Review Comments - Upper Aquifers + Trench Memos

Review Comments
Technical Brief
Proposal to Modify the Groundwater Extraction Trench
Perimeter Groundwater Collection System (PGCS)
American Chemical Services, Inc.
March 20, 1996

Review Comments
Upper Aquifer Investigation Technical Memorandum, March 15, 1996
American Chemical Services, Inc.

FIGURE 1

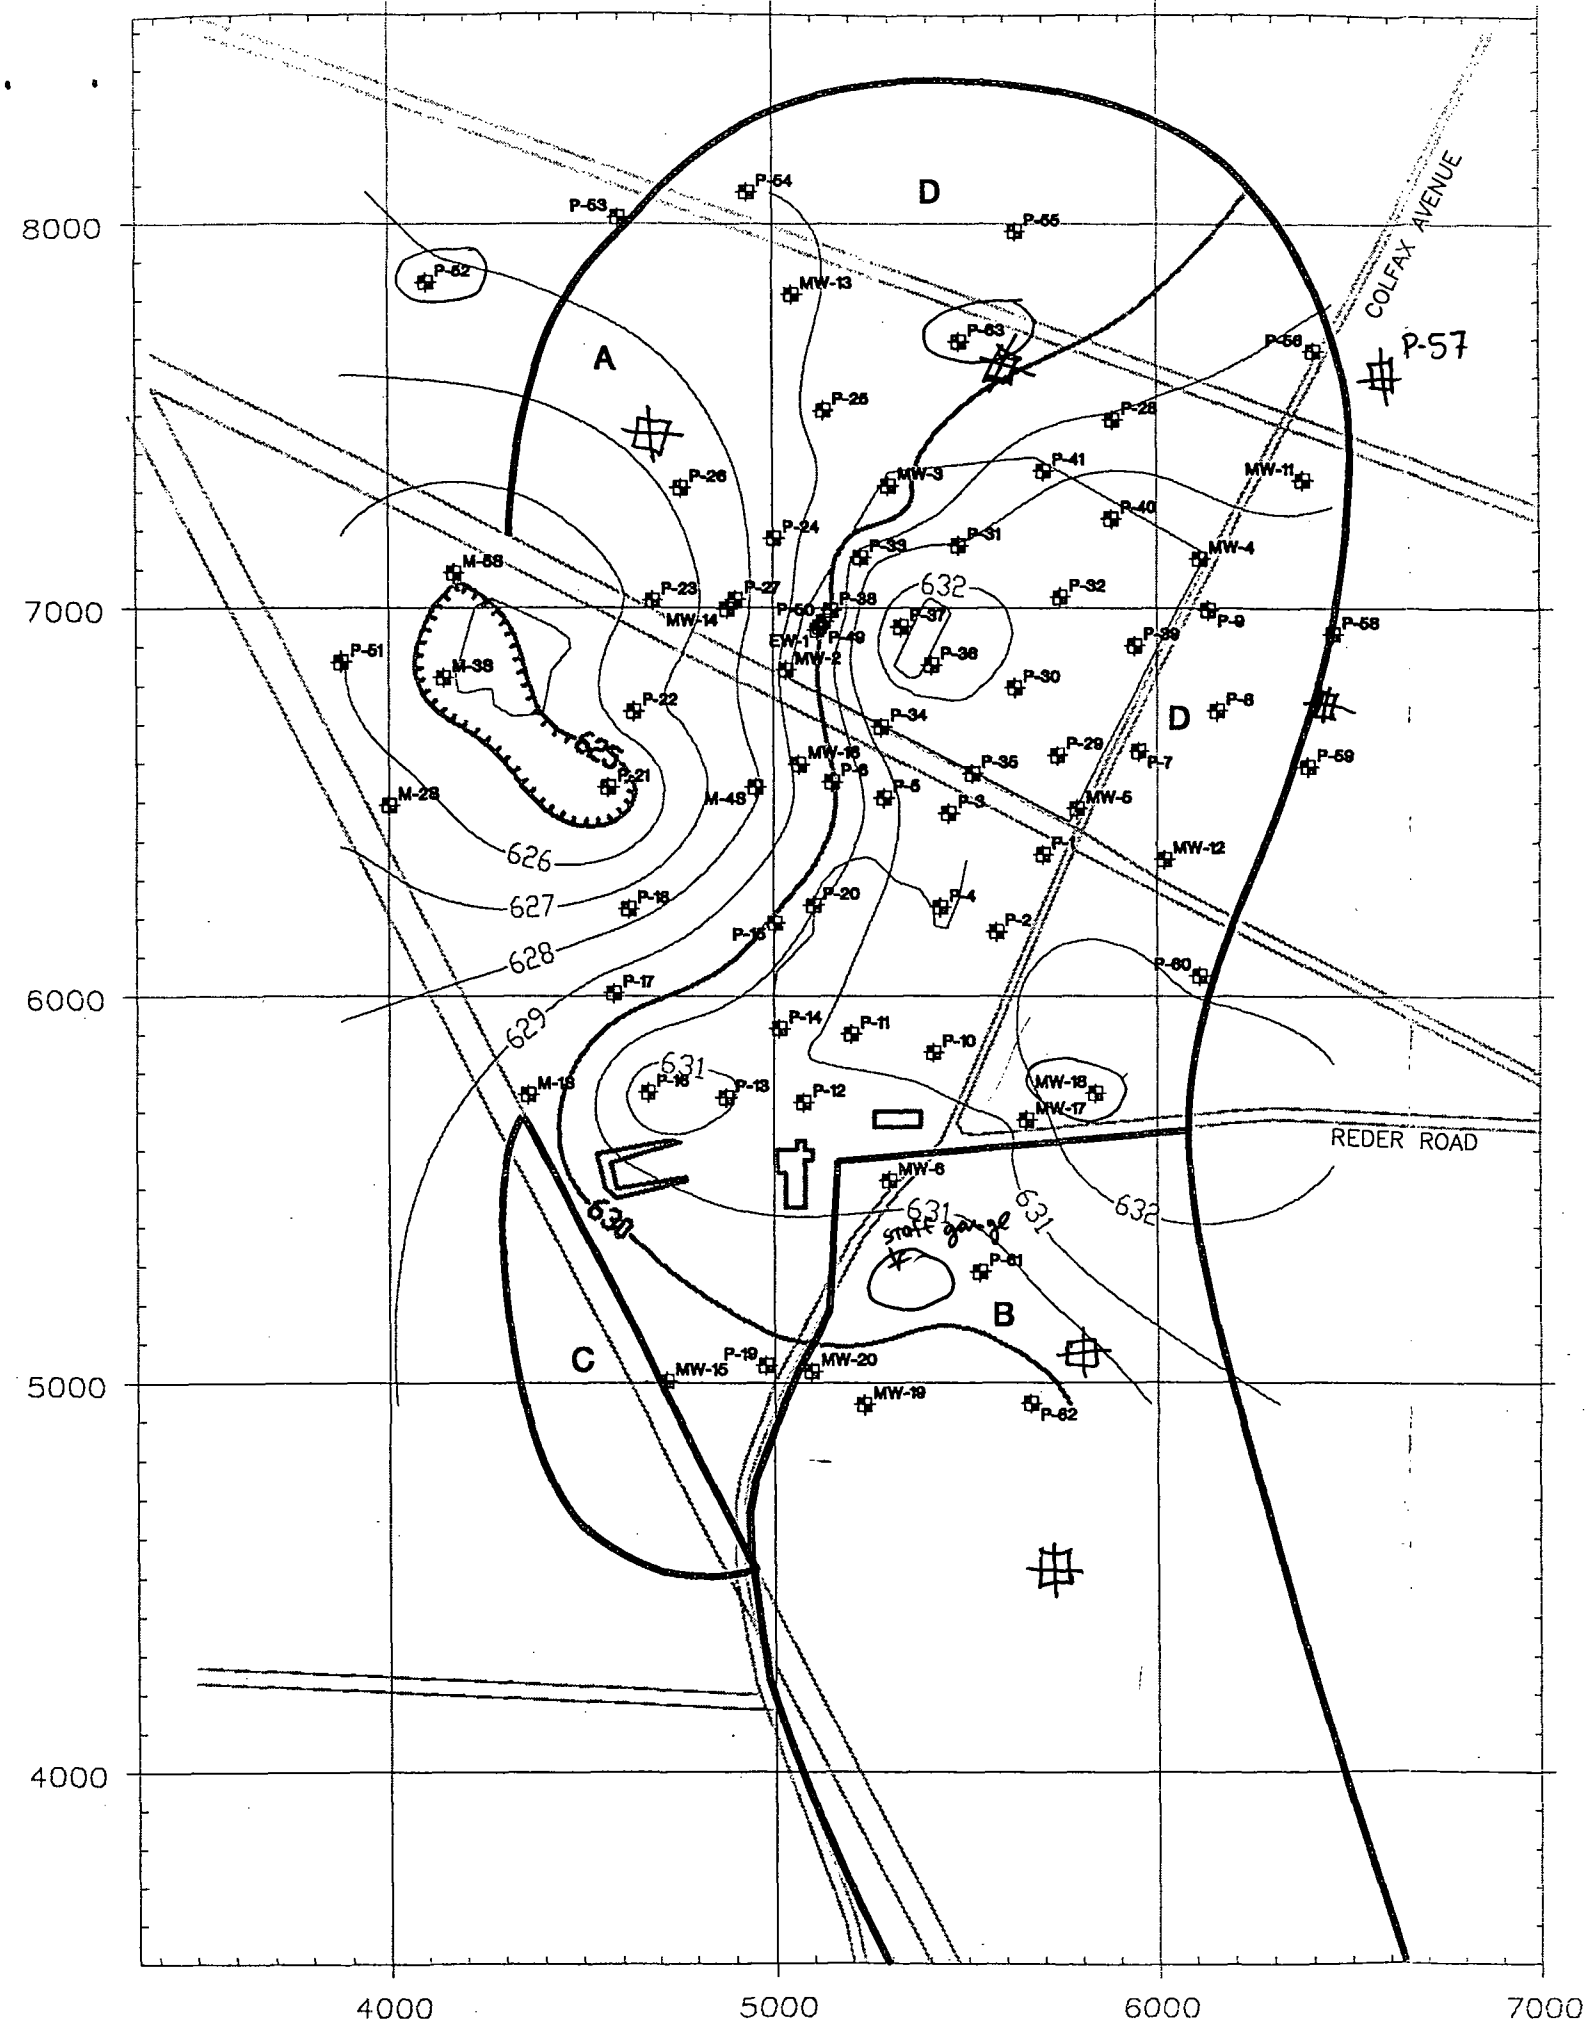
The boundaries of bulleted areas A,B,C, and D described in this paragraph are not clear. Present the boundaries of these areas on figure 1.

Present the location of MW-9 on figure 1.

P-57, as indicated in the Montgomery Watson technical memorandum dated November 8, should be installed.

A staff gauge should be installed in the retention pond south of Colfax Avenue and Reder Road, as verbally proposed by Montgomery Watson.

With the included modifications, the general locations of the monitoring wells are acceptable. However, final locations will be verified by USEPA and IDEM in the field.
